**SUBJECT:** Entergy Nuclear Operations, Inc.  
Pilgrim Nuclear Power Station  
Docket 50-293  
License No. DPR-35

Pilgrim Nuclear Power Station License Renewal Application Annual Update Supplement (TAC MC9669)

**LETTER NUMBER:** 2.10.046

Entergy Response to Additional Information Related to  
Pilgrim License Renewal Annual Update Changes

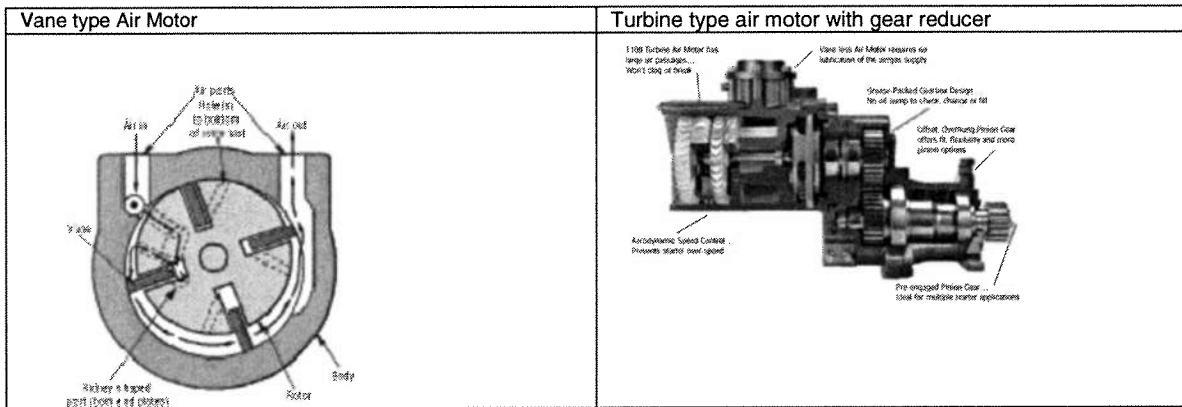
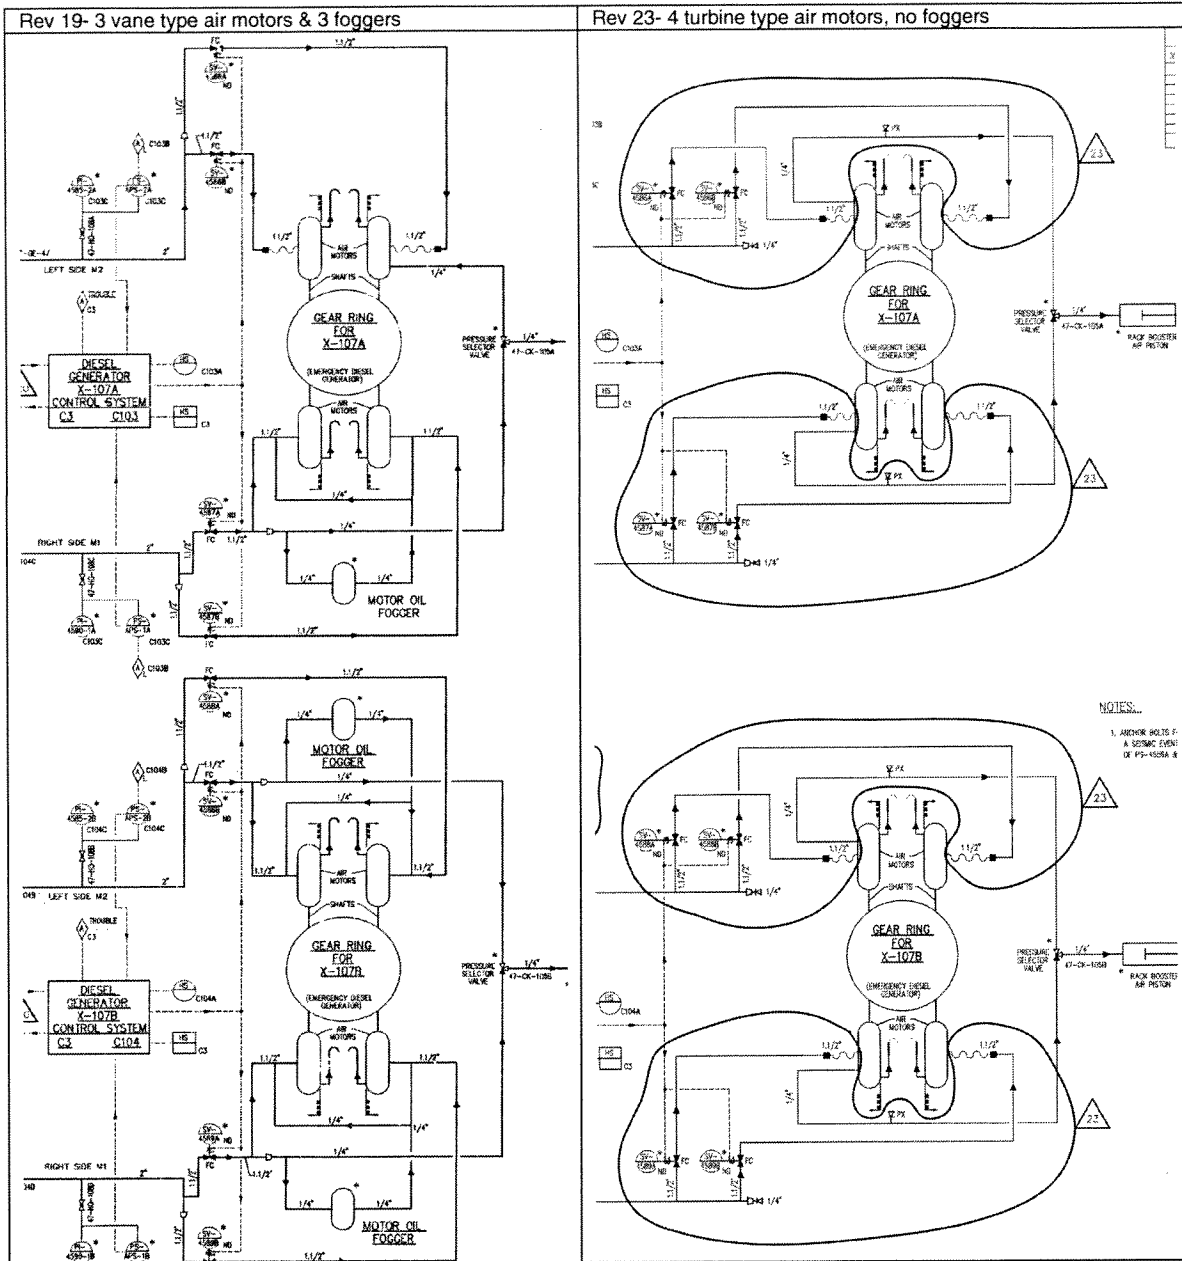
Pilgrim's LRA Drawing M219 showed a component identified as a "Motor Oil Fogger" in the piping from the Emergency Diesel Generator (EDG) air receiver tanks to one of the two sets of air start motors on the "A" EDG. The drawing showed "Motor Oil Foggers" in the piping on both sets of the air start motors for "B" EDG. The "Fogger Housing" described a unique component type whose integrity would be necessary to assure accomplishment of EDG intended function. PNPS License Renewal Annual Update Letter # 2.09.074 discussed the deletion of the "Fogger Housing" resulting in the following questions.

- How "Fogger Housing" is no longer required to support EDG intended function?
- How the pressure boundary function is being achieved?

- The new EDG air start motors do not require lubricated air, so the motor oil foggers with their “Fogger Housings” are no longer required.
- When the foggers were removed they were replaced with air piping components maintaining the pressure boundary.

The Motor Oil Fogger and its housing are no longer needed to support the EDG intended function because the recently installed turbine type air motor does not require lubricated air. The original vane type motors utilize sliding vanes that rub against the motor housing walls and because of this internal friction vane type motors require oil foggers to provide constantly lubricated air.

The turbine type air motor uses blades to convert pneumatic power to mechanical power; the internal parts do not rub against the walls. The turbine type motor has permanently lubricated bearings and does not require an oil fogger as part of its air supply system.

The vane type air start motors were replaced with turbine type air start motors using the Pilgrim Design Change Process (PDC 00-12, PDC 03-59, and EC0000012969); a PDC is a Plant Design Change, which is now called an EC, or an Engineering Change. The modifications were done over a period of years, during periods when the individual EDGs were out of service for extended PMs. This was intentionally scheduled to minimize the EDG System unavailability. This staged approach was the reason that LRA drawing M219 reflected “Fogger Housings” on some, but not all air lines to the air start motors.

The design changes installed the turbine type air motors on the EDGs, and removed the oil fogger, housing, and the inlet/outlet piping connections to the air starting system. The air pressure regulators, solenoid valves, and manual operating valves were replaced at the same time with higher air flow capacity units which maintain the pressure boundary. This reduced the differential pressure losses through the components, thereby providing increased oil pressure at the air motor. Post work tests were conducted to validate, and confirm that the air system performance met FSAR requirements. At this time, all vane type air motors have been replaced with turbine type air motors, and there are no “Motor oil Foggers” or “Fogger Housings” on the EDG air start systems.

A comparison of the P&ID drawings M219 revisions demonstrates that the air system boundary was maintained and controlled as each set of vane type air motors were replaced with turbine type air motors. The following sections from P&ID drawing M219 shows the progression from a single turbine style air motor (and 3 vane type motors with oil foggers) as shown in the LRA drawing (Rev 19) , to the current configuration with 4 turbine style air motors (Rev 23), and no motor oil foggers.
